**Planning Committee Wednesday 20th November 2019
Addendum**

19/2646/FUL – Collis Primary School, Teddington - Pages 9-49

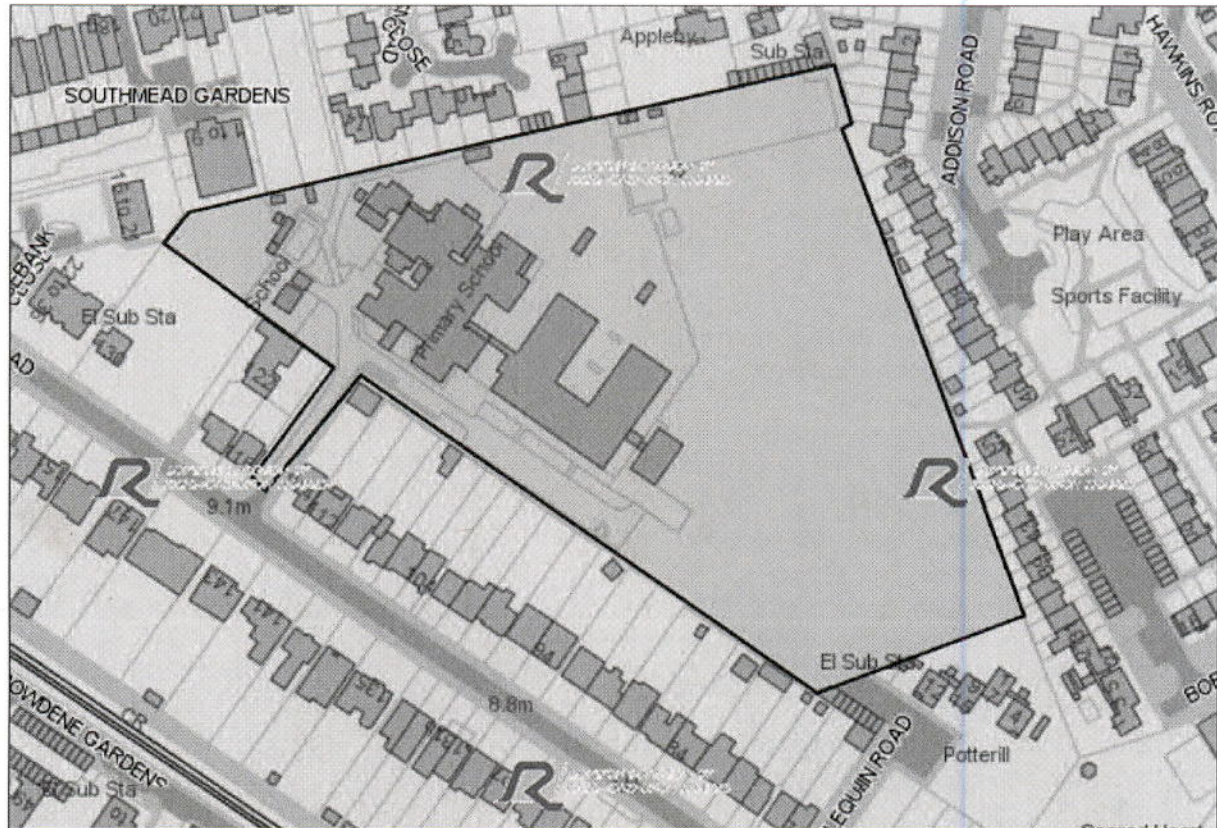
Replace condition NS01 with following

The new front wall shown on approved drawing no: 04 Rev A shall be constructed to a height and brickwork finish to match the existing front wall and prior to the commencement of occupation of the extension hereby approved.

Reason In the interest of the appearance of the site and pedestrian safety.
